Attachment No. 2
Revised set of Plans

IDALS CAL883432B NUTRIENT REDUCTION WETLAND

CONSTRUCTION PLANS

ISG PROJECT # 24-30402

C0-20

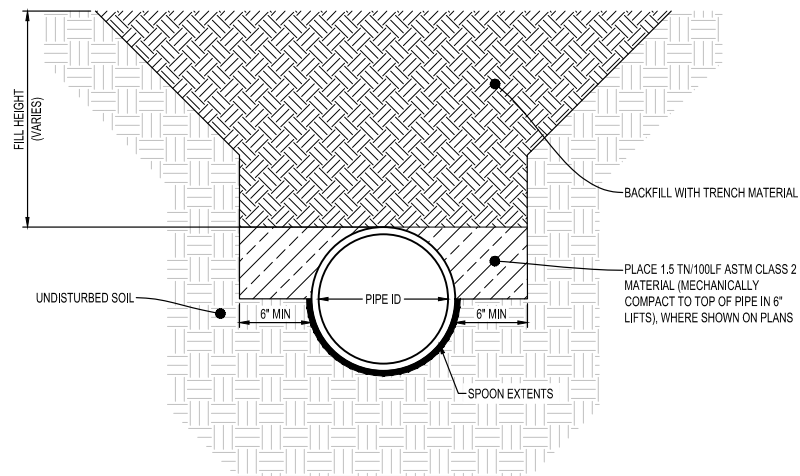
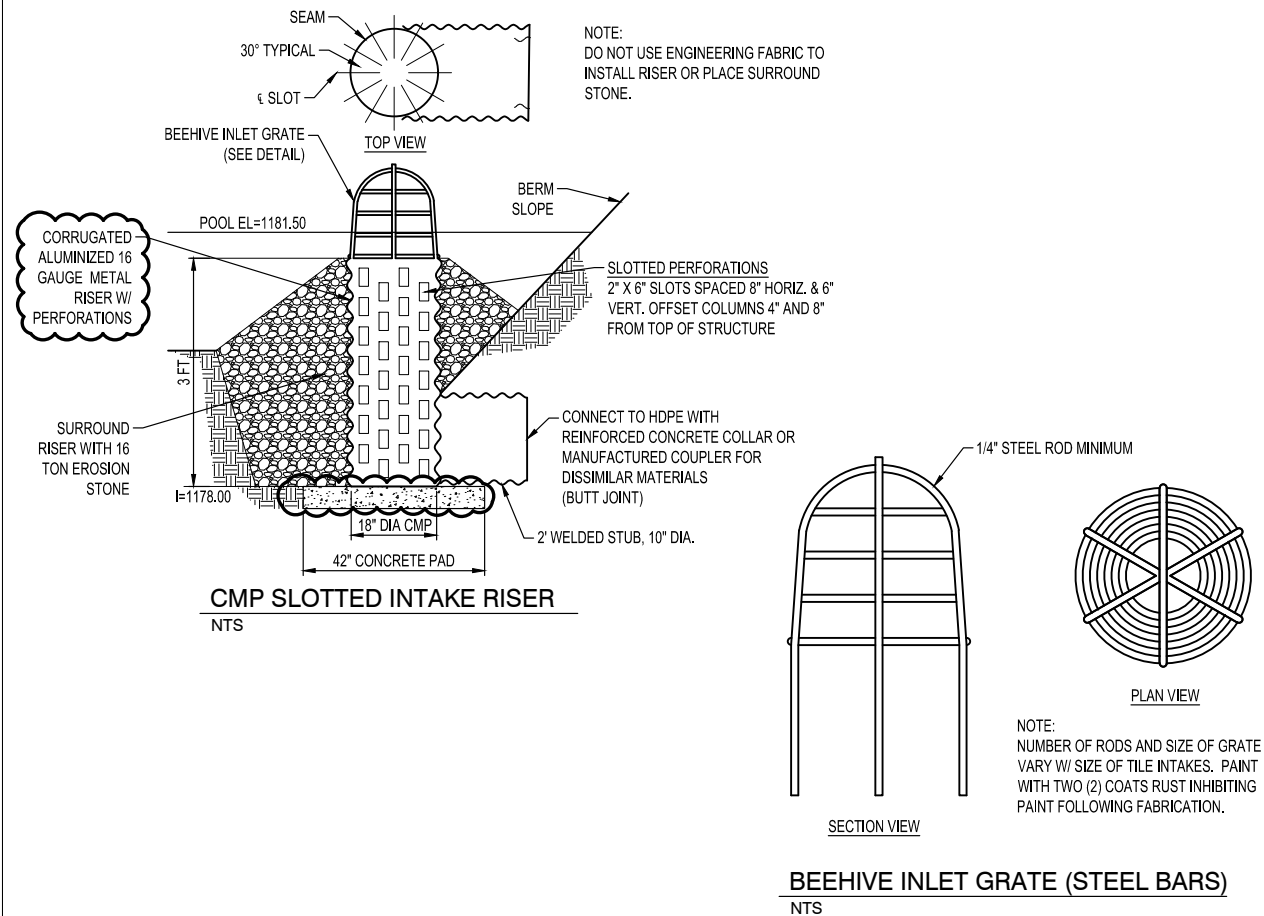
REVISION SCHEDULE		
DATE	DESCRIPTION	BY
8-13-2026	ADD SILT FENCE TO IOW & INSPC	HLC

C0-31

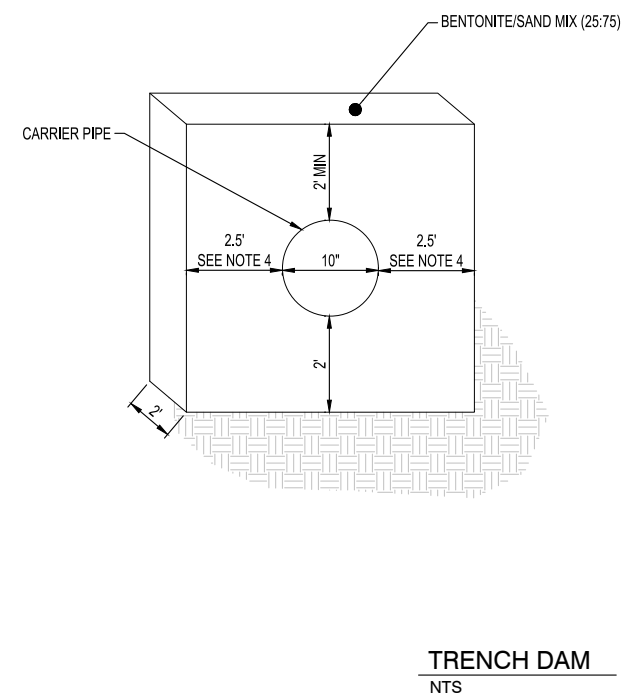
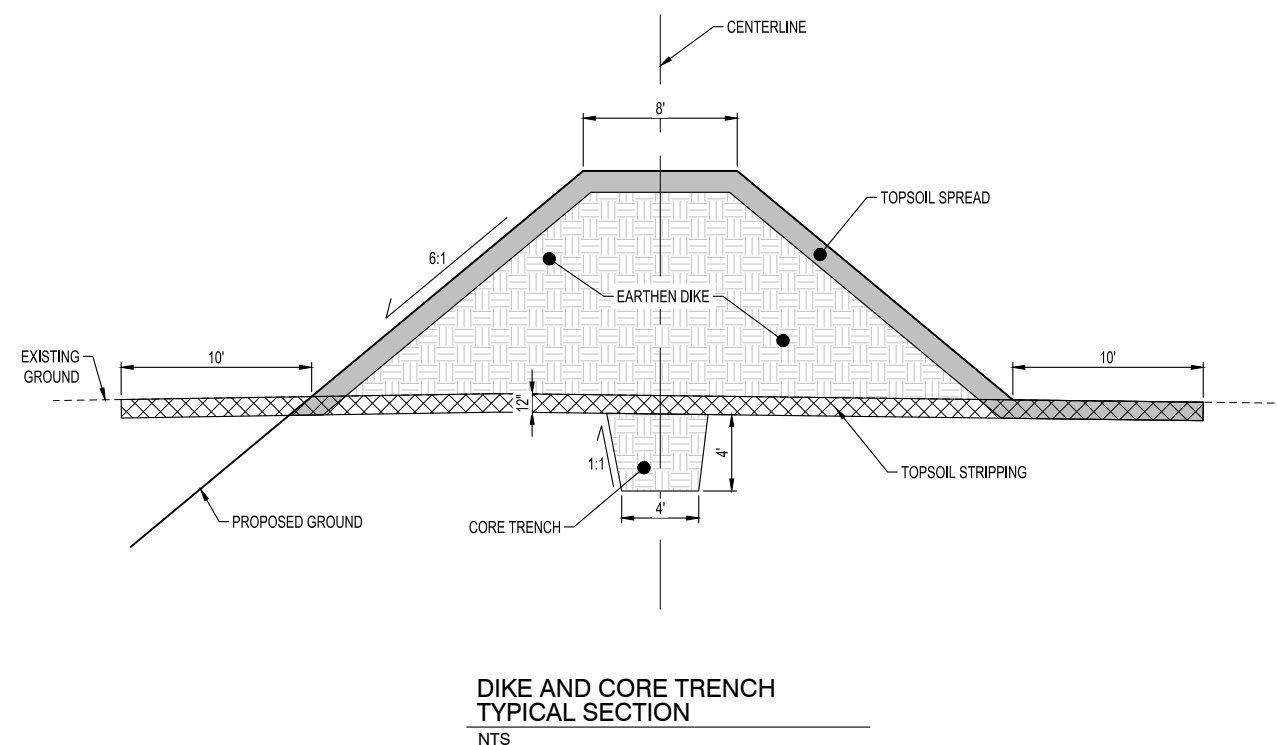
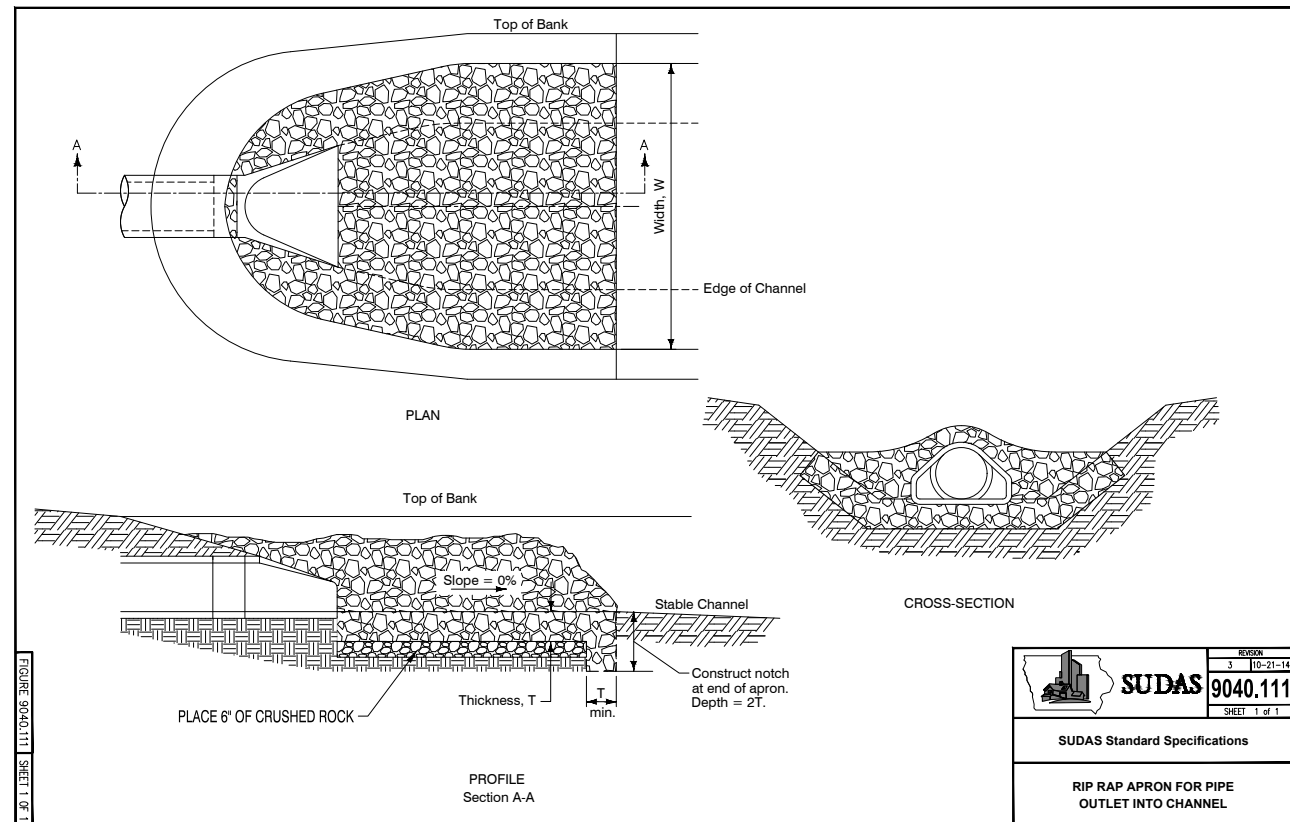
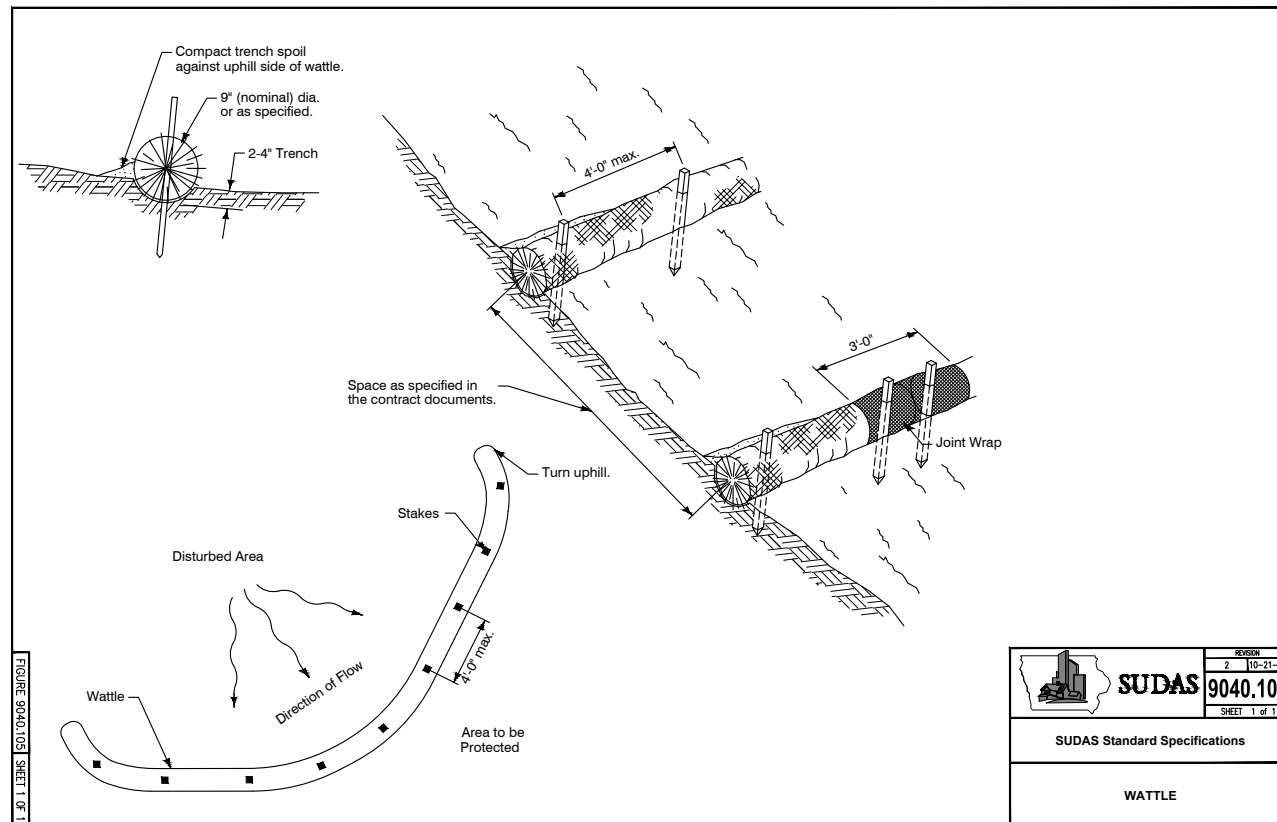
REVISION SCHEDULE		
DATE	DESCRIPTION	BY
8-13-2026	ADDED SILT FENCE DETAIL	HLC

SHEET
C1-10

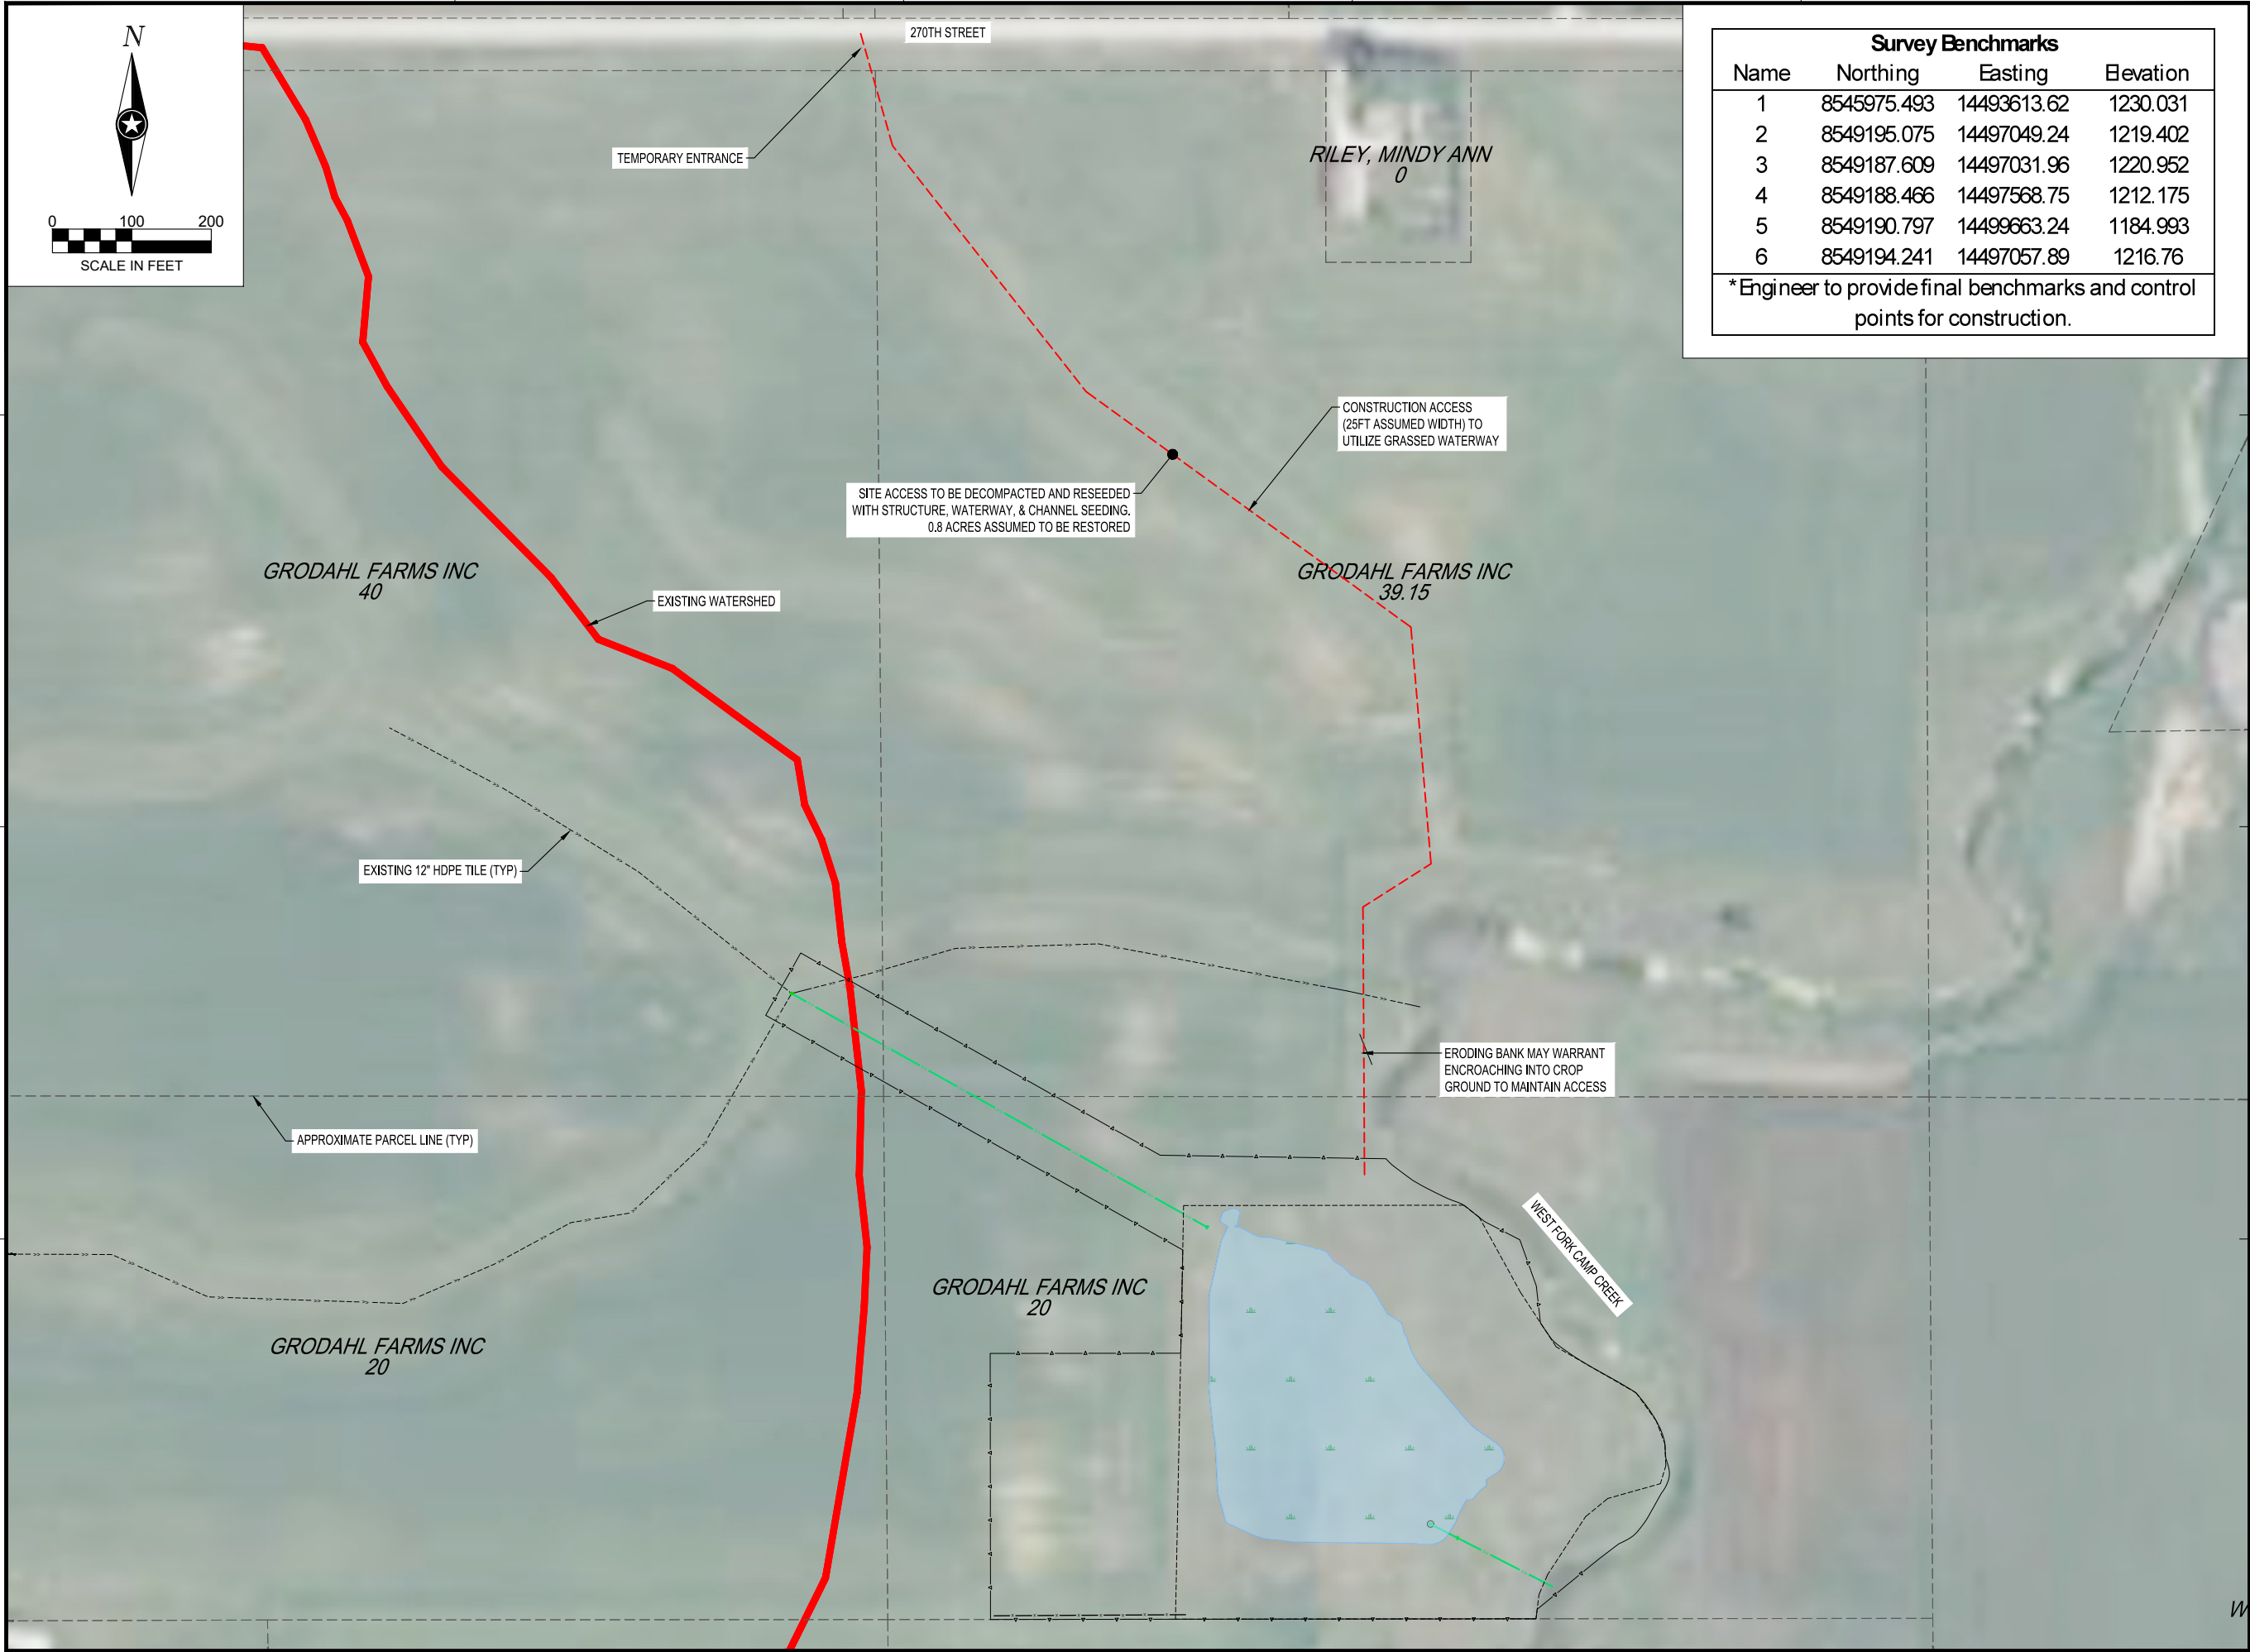
REVISION SCHEDULE		
DATE	DESCRIPTION	BY
8-13-2026	ADDED SILT FENCE OUTLINES AND ANNOTATIONS	HLC
